2018 Wellington control zone amendment
Final airspace changes

In mid-December 2016, Airways submitted an application to amend the Wellington control zone (CTR) and with consequential amendments to some Wellington control areas (CTA) to contain new PBN instrument procedures. Consultation was initiated with users in January with a cut-off date of 1 March 2018 for submissions.

Figure 1 – requested western boundary change and new eastern VFR transit lane

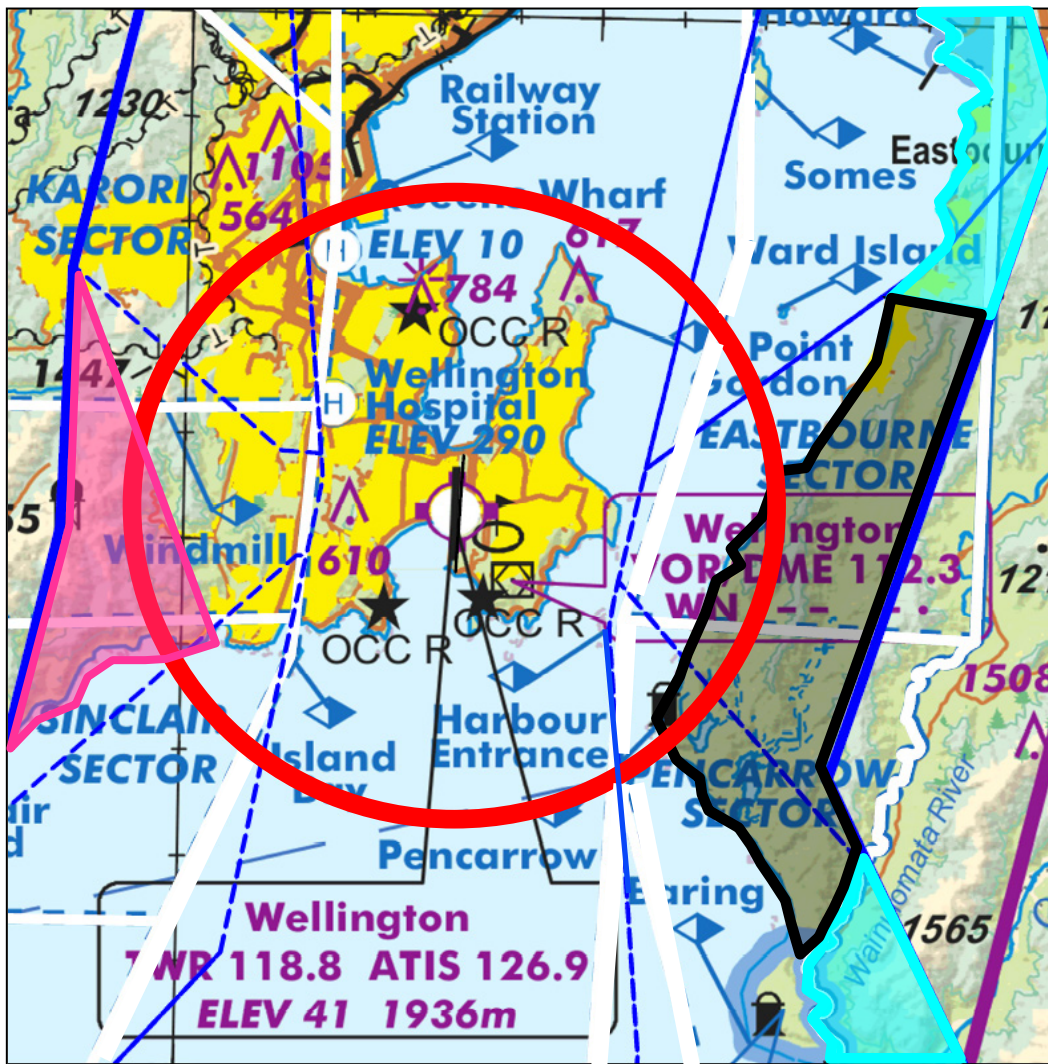
One submission requested that the western boundary of proposed CTR be moved to the east of Hawkins Hill, as detailed in Airways' petition on page 13, to facilitate hang glider/paraglider operations north of the coast from Sinclair Head. Following the user consultation meeting, it was additionally proposed that the CTR boundary between Sinclair Head and Owhiro Bay be amended to follow a line parallel with the coast, 100 m out to sea.

The western boundary of the amended CTR is just outside 3 NM from Wellington airport. Refer to Figure 1, page 8, showing the 3 NM radius from Wellington airport depicted in red, and the requested boundary change in pink. While noise abatement requirements has placed the aerodrome circuit for both runways to the east, over the harbour, there are still aircraft operations over the city.

Two submitters requested the extension of the northern transit lane southwards along the eastern harbour coastline. One was to Pencarrow VRP and the other was to link up with the new Turakirae VFR transit lane.

Refer to Figure 1. The area outlined in black would be the section joining the new northern VFR transit lane and the new Turakirae VFR transit lane.

To ensure that circuit traffic, i.e. aircraft receiving an aerodrome control service, does not conflict with uncontrolled aircraft, a radius of 3 NM from Wellington airport depicts a notional circuit area. The red circle in Figure 1 depicts the 3 NM radius from Wellington, and as shown, the requested VFR transit lane extends into this area.

CAA has reviewed this request. Based on the technical data above, CAA is not satisfied that amending the boundary as requested would provide adequate containment for the Runway 16 turning departures to the south-west.

The proposed boundary changes to Wellington CTR/C will proceed as requested by Airways.

This request will not be progressed for the above reasons.
